• **DRIVEABILITY—IDLE—LOW ENGINE RPM DURING INITIAL COLD START OR LOSS OF ENGINE POWER AFTER CLUTCH DISENGAGEMENT OR ON DECELERATION—VEHICLES EQUIPPED WITH 4.0L SOHC ENGINE ONLY** • **DRIVEABILITY—STALL—LOSS OF ENGINE POWER AFTER CLUTCH DISENGAGEMENT OR ON DECELERATION—VEHICLES EQUIPPED WITH 4.0L SOHC ENGINE ONLY**	**Article No. 01-23-2**

FORD: 2001 RANGER

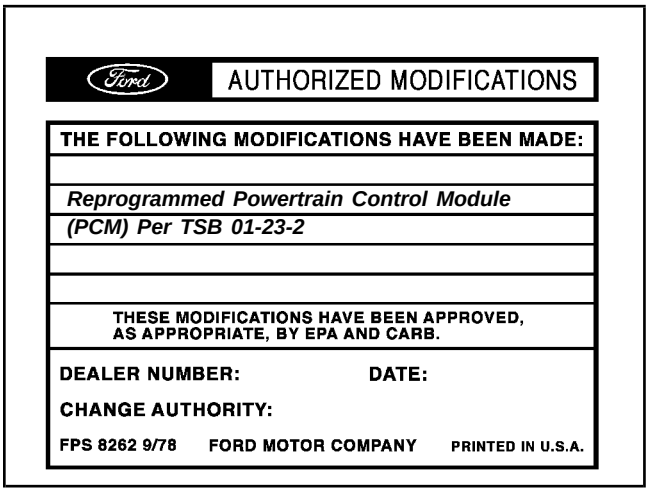
1. Perform normal diagnostics as outlined in the 2001 Powertrain Control/Emissions Diagnosis (PC/ED) Workshop Manual and service as required.
2. If the condition is still present, install one hose clamp, part W527209-S301, to the PCV Closure Tube, where the elbow mates to the valve cover. This closure tube goes from the clean air tube to valve cover.
3. Reprogram the PCM using the Worldwide Diagnostic System (WDS), or New Generation Star (NGS) Tester. Refer to the following PCM Calibration Information Chart.
